Variance Request Form

Ocotillo Express Wind LLC
Pier 1 Bay 3
San Francisco CA 94111
415-283-4000

Variance: 015
Request No.: Rev 0
Date Submit: 8/22/2012
Date Approval Needed: 8/24/2012
Date Agency Received: _____
Agency Approval Reference No.: _____

OCOTILLO WIND PROJECT: IMPERIAL COUNTY, CALIFORNIA

VARIANCE 15 - AUGUST 20, 2012

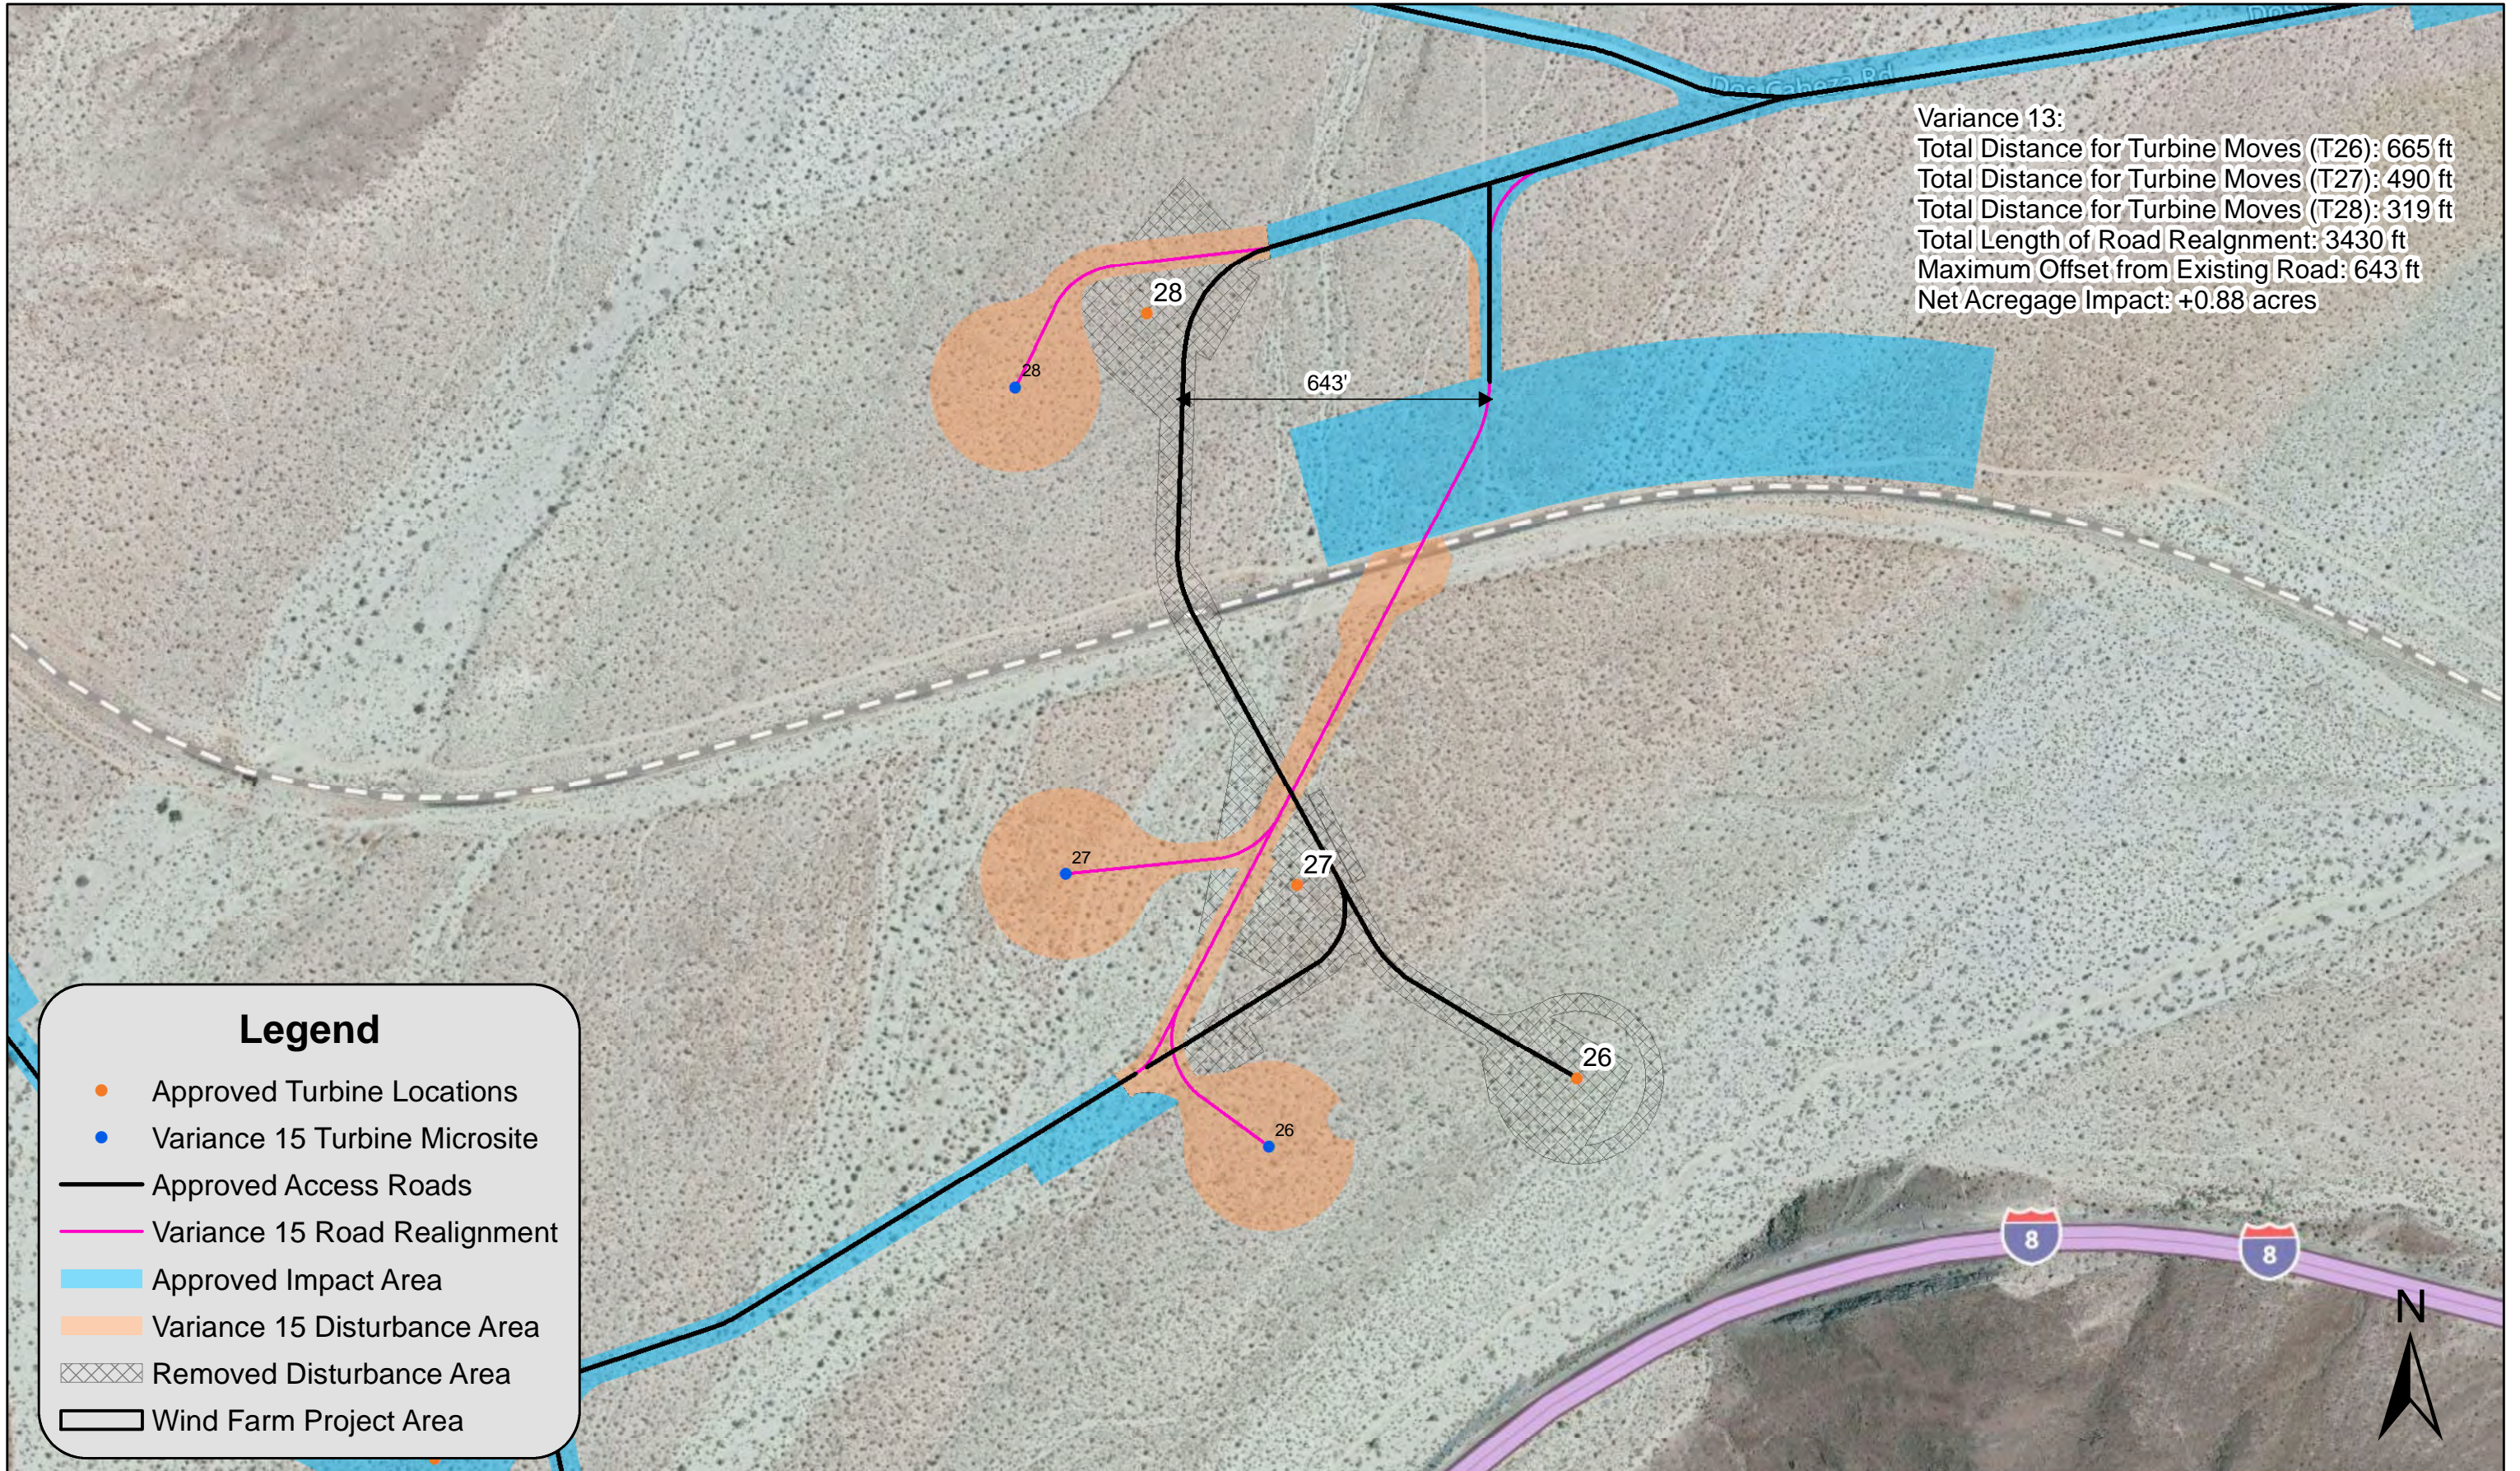
Variance 015 includes a shift of Wind Turbines 26, 27, 28 and the realignment of the associated access road and collection circuit corridors (see map attachment). The proposed variance will shift Wind Turbines 26, 27 and 28, distances of 665, 490, and 319 feet, respectively, from the currently approved turbine locations. The access road and collection circuit realignments have a maximum offset of 645 feet from the currently approved access road and collection circuit corridors.

Variance 13:
 Total Distance for Turbine Moves (T26): 665 ft
 Total Distance for Turbine Moves (T27): 490 ft
 Total Distance for Turbine Moves (T28): 319 ft
 Total Length of Road Realignment: 3430 ft
 Maximum Offset from Existing Road: 643 ft
 Net Acreage Impact: +0.88 acres
